STAFF REPORT
KETCHUM PLANNING AND ZONING COMMISSION
REGULAR MEETING OF TUESDAY, OCTOBER 13TH, 2020

PROJECT: Waddell-Roush Townhouse Preliminary Plat

FILE NUMBER: P20-058

PROJECT NO. 20003
PRELIMINARY PLAT

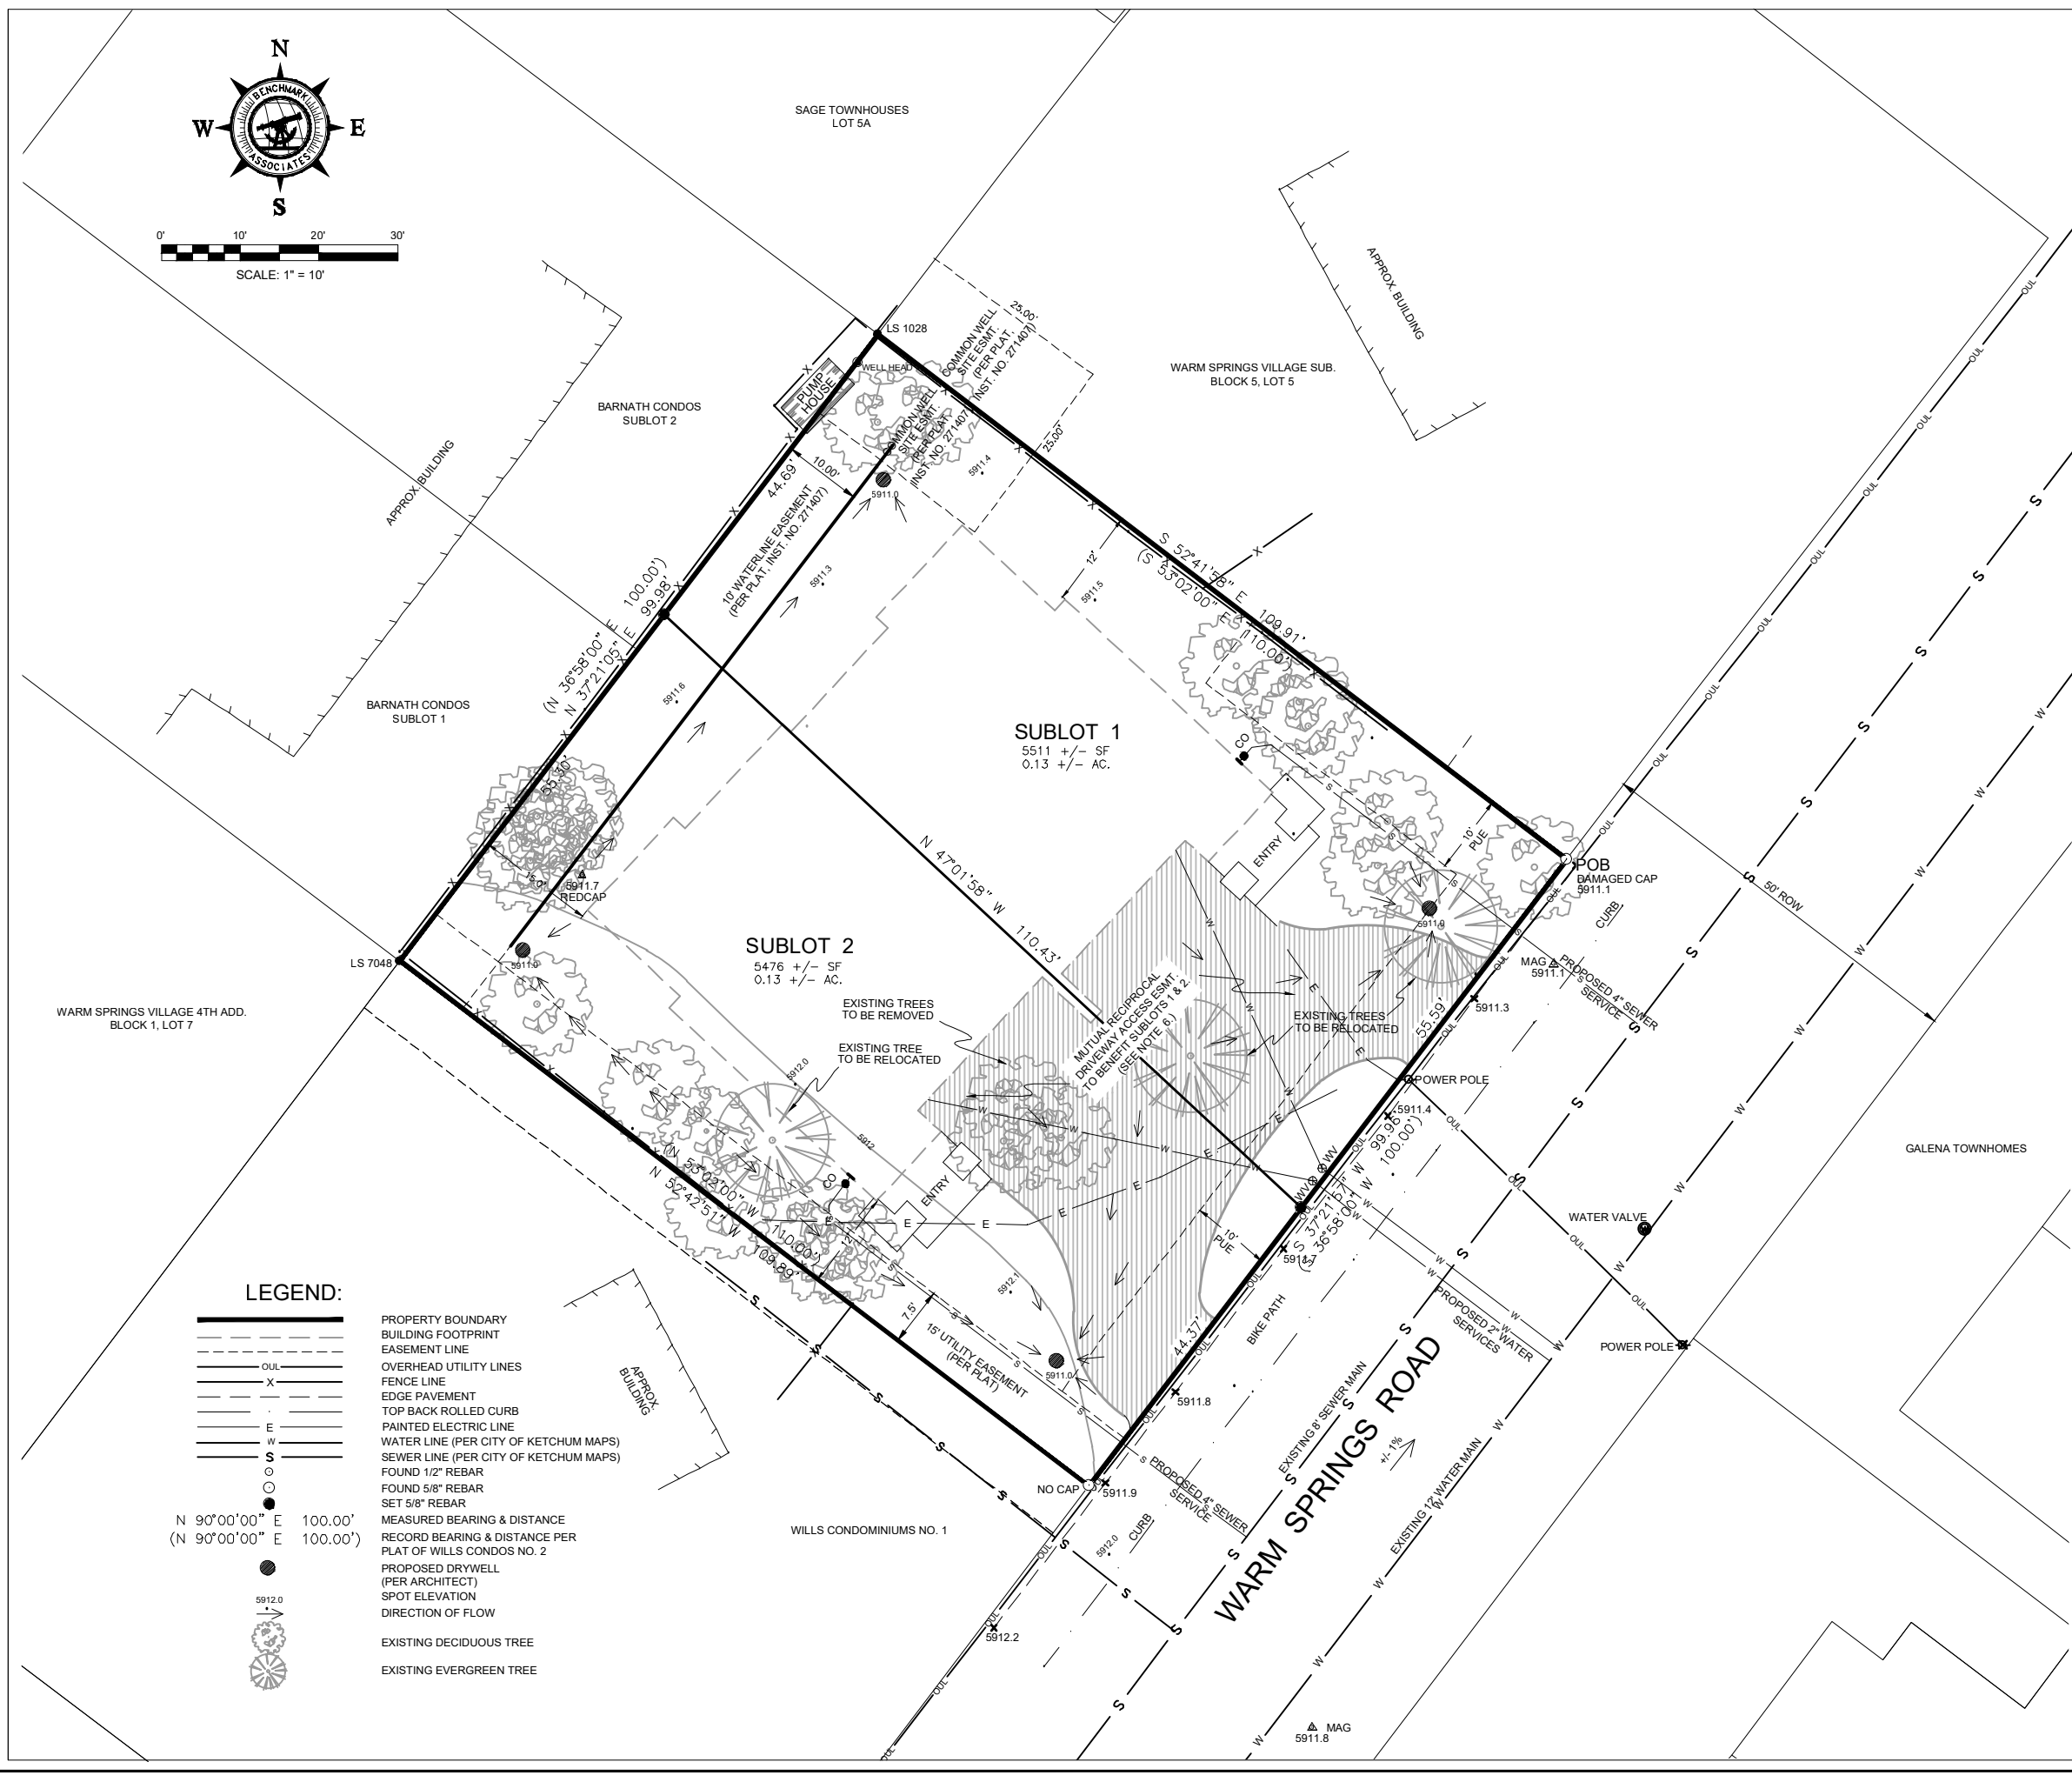
Findings	<i>This standard has been met. No new streets are proposed. The subplot lines and dimensions are indicated on the preliminary plat.</i>
<input checked="" type="checkbox"/>	<input type="checkbox"/>	<input type="checkbox"/>	16.04.030.J.11	The location, approximate size and proposed use of all land intended to be dedicated for public use or for common use of all future property owners within the proposed subdivision.
			Findings	<i>No land for common or public use is required or proposed.</i>
<input checked="" type="checkbox"/>	<input type="checkbox"/>	<input type="checkbox"/>	16.04.030.J.12	The location, size and type of sanitary and storm sewers, water mains, culverts and other surface or subsurface structures existing within or immediately adjacent to the proposed sanitary or storm sewers, water mains, and storage facilities, street improvements, street lighting, curbs, and gutters and all proposed utilities.

Findings	<i>The plat indicates the proposed locations of all utilities service the townhome development. No street infrastructure improvements are proposed with this project.</i>
<input type="checkbox"/>	<input type="checkbox"/>	<input checked="" type="checkbox"/>	16.04.030.J.13	The direction of drainage, flow and approximate grade of all streets.
			Findings	<i>N/a as no new streets are proposed.</i>
<input checked="" type="checkbox"/>	<input type="checkbox"/>	<input type="checkbox"/>	16.04.030.J.14	The location of all drainage canals and structures, the proposed method of disposing of runoff water, and the location and size of all drainage easements, whether they are located within or outside of the proposed plat.
			Findings	<i>Civil drawings for the drainage improvements were reviewed and approved with the Building Permit application.</i>
<input checked="" type="checkbox"/>	<input type="checkbox"/>	<input type="checkbox"/>	16.04.030.J.15	Vicinity map drawn to approximate scale showing the location of the proposed subdivision in reference to existing and/or proposed arterials and collector streets.

Findings	<i>The required public utility along Warm Springs Road is reflected on the plat. All other existing and necessary easements are indicated on the plat.</i>
<input type="checkbox"/>	<input type="checkbox"/>	<input checked="" type="checkbox"/>	16.04.040.J.2	<p>2. Where a subdivision contains or borders on a watercourse, drainageway, channel or stream, an easement shall be required of sufficient width to contain such watercourse and provide access for private maintenance and/or reconstruction of such watercourse.</p>
			Findings	<i>N/A. The townhouse sublots do not border a waterway.</i>
<input type="checkbox"/>	<input type="checkbox"/>	<input checked="" type="checkbox"/>	16.04.040.J.3	<p>3. All subdivisions which border the Big Wood River, Trail Creek and Warm Springs Creek shall dedicate a ten foot (10') fish and nature study easement along the riverbank. Furthermore, the Council shall require, in appropriate areas, an easement providing access through the subdivision to the bank as a sportsman's access. These easement requirements are minimum standards, and in appropriate cases where a subdivision abuts a portion of the river adjacent to an existing pedestrian easement, the Council may require an extension of that easement along the portion of the riverbank which runs through the proposed subdivision.</p>

2. This preliminary plat approval is subject to Building Permit 20-079 and Design Review approval P20-031. All conditions of approval shall apply.
3. The recorded plat shall show a minimum of two Blaine County Survey Control Monuments with ties to the property and an inverse between the two monuments. The Survey Control Monuments shall be clearly identified on the face of the map.

4. An electronic CAD file shall be submitted to the City of Ketchum prior to final plat signature by the City Clerk. The electronic CAD file shall be submitted to the Blaine County Recorder’s office concurrent with the recording of the Plat containing the following minimum data:

- a. Line work delineating all parcels and roadways on a CAD layer/level designated as “parcel”;
 - b. Line work delineating all roadway centerlines on a CAD layer/level designated as “road”; and,

- c. Line work that reflects the ties and inverses for the Survey Control Monuments shown on the face of the Plat shall be shown on a CAD layer/level designated as “control”; and,

- d. All information within the electronic file shall be oriented and scaled to Grid per the Idaho State Plane Coordinate System, Central Zone, NAD1983 (1992), U.S. Survey Feet, using the Blaine County Survey Control Network. Electronic CAD files shall be submitted in a “.dwg”, “.dgn” or “.shp” format and shall be submitted digitally to the City on a compact disc. When the endpoints of the lines submitted are indicated as coincidental with another line, the CAD line endpoints shall be separated by no greater than 0.0001 drawing units.
